UNITED STATES ENVIRONMENTAL PROTECTION AGENCY
WASHINGTON, D.C. 20460

DOCKET NO: A-98-49, II-A4-149

EPA TIER 1 EVALUATION
OF THE CENTRAL CHARACTERIZATION PROJECT
REMOTE-HANDLED TRANSURANIC WASTE CHARACTERIZATION PROGRAM:
ADDITION OF WASTE STREAM SR-RL-BCLDP.002 CONSISTING
OF DRUM NUMBER BC0148 FROM THE BATTELLE COLUMBUS LABORATORY
SABOTAGE PROGRAM

June 2011

Figure 1. Flow Diagram of the Characterization Process for SR-RL-BCLDP.002

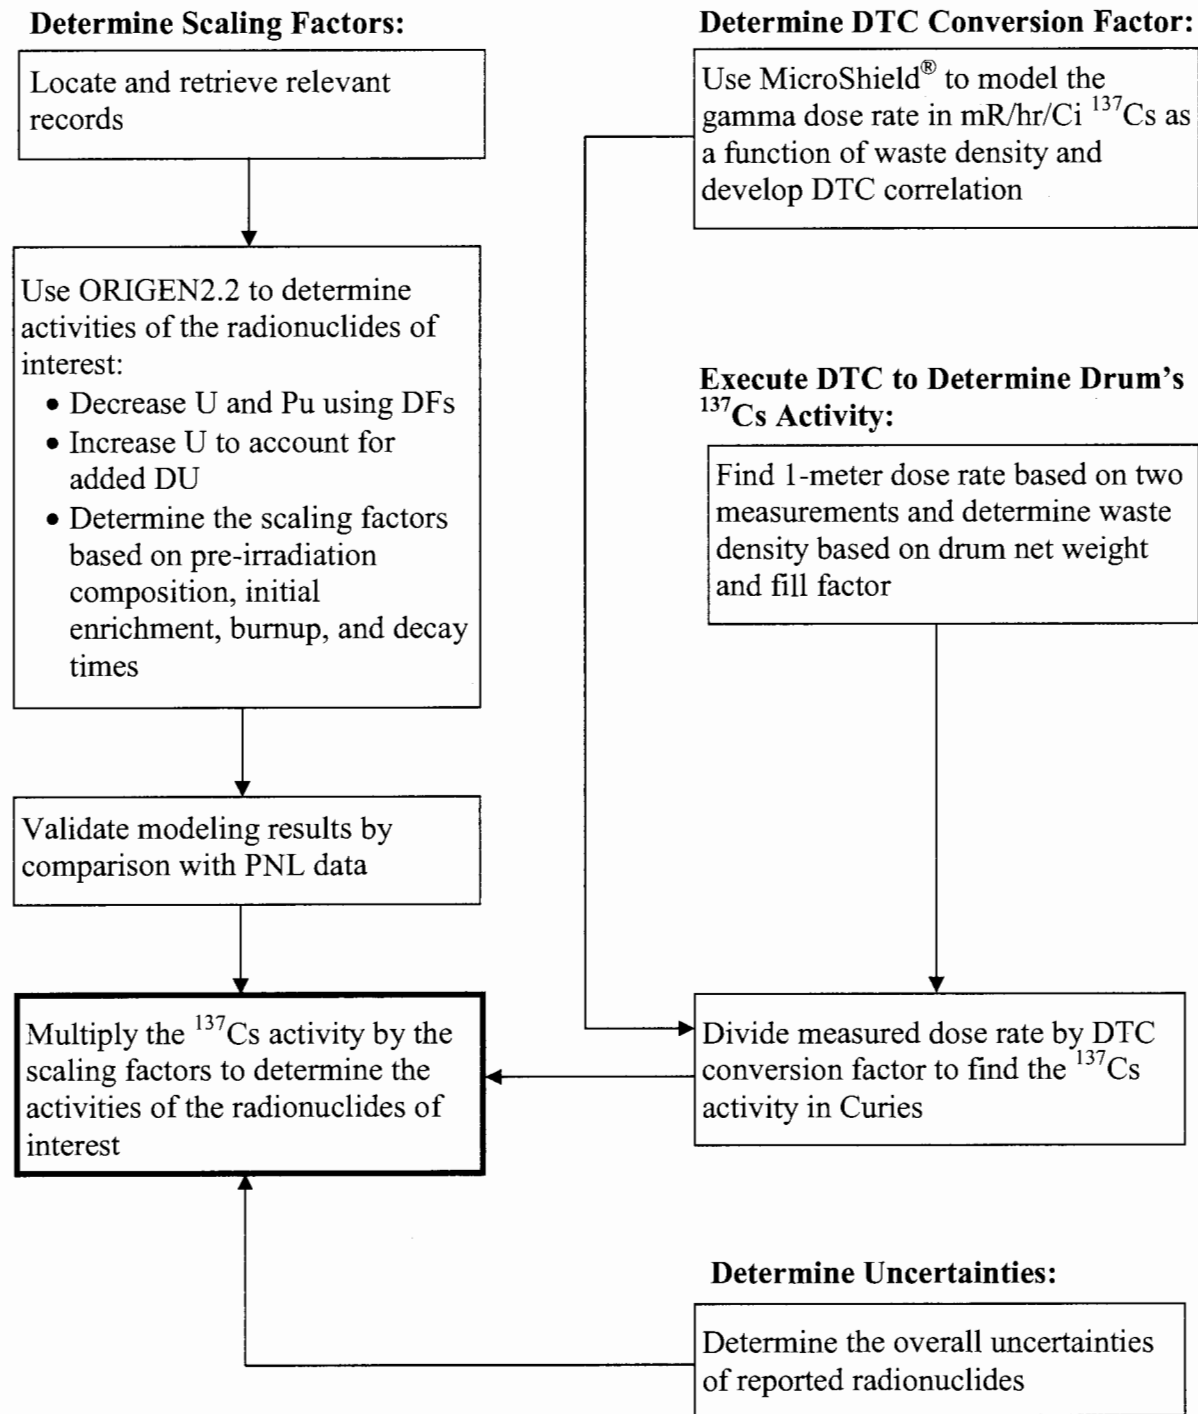
- (1) The overall radiological characterization process was technically adequate and appropriately documented.

The components of the process to characterize Drum No. BC0148 are presented in Figure 1, below. This radiological characterization process was comparable to what EPA inspected and approved during the SRS-CCP RH baseline in August 2008 and one subsequent T1 evaluation in September 2010 cited earlier. The radiological characterization was found to be technically adequate and appropriately documented.
